**DESIGN REPORT**  
*FOR*  
**KAHLE WATER QUALITY BASIN**  
**IMPLEMENTATION PROJECT**  
*STATELINE, NEVADA*

**March 2018**

APPENDIX A: RESPONSES TO 50% COMMENTS .....13

APPENDIX B: RESPONSES TO 90% COMMENTS.....14

Figure 3. Sub-watershed boundaries for Existing and Proposed Hydrology.

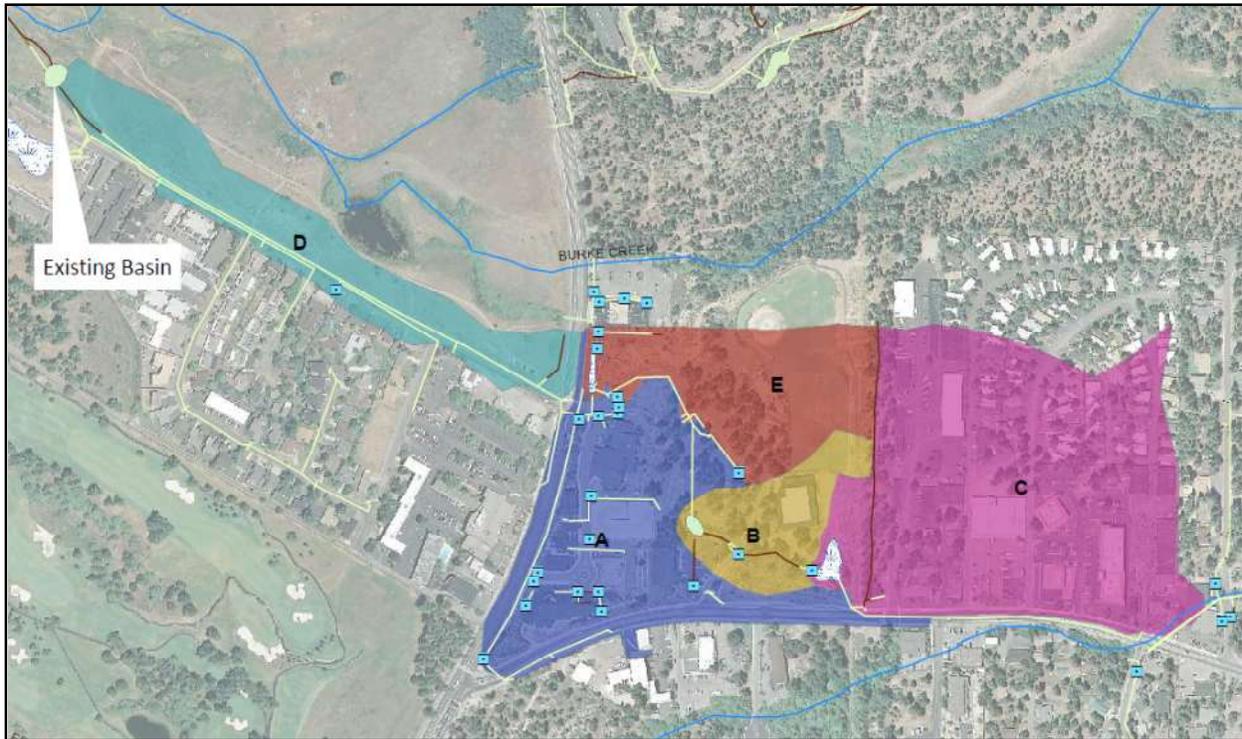
| Comment # | Document/Page | Comment   | Commenter       | Response   |
|-----------|---------------|---|-----------------|--|
| 29        | DesignReport  | Page 5, Figure 3 - The sub-watershed boundaries need to be updated. I have been basing catchment boundaries on the DCA catchment and adding on what you have outlined here as "D". Table 2.1 will need to be updated based on the revised estimated flow estimates for the area draining to the basin.                                | Courtney Walker | The sub-watersheds are valid for the hydrology we did for the project and should not be updated or we have to redo the hydrology which we'd like to keep as is because it is accurate enough for design. The subwatersheds should be re-done for PLRM. |

Figure 4. Final design basin location relative to existing basin and conceptual design basins.

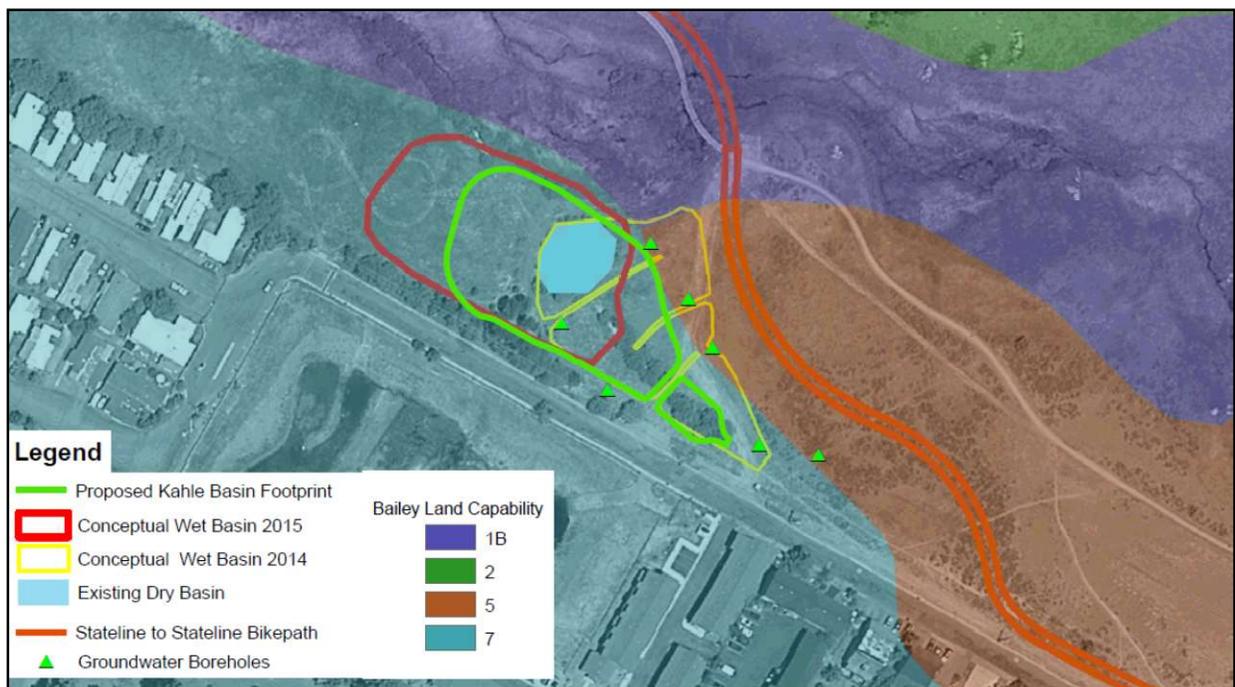
| Comment # | Document/Page  | Comment   | Commenter        | Response  |
|-----------|----------------|---|------------------|---|
| 3         | Design Report  | Cannot tell the land capability districts because the image is in black and white.  | Shannon Friedman | Replaced the image with a better image. LCV districts are also on the engineering plans.  |
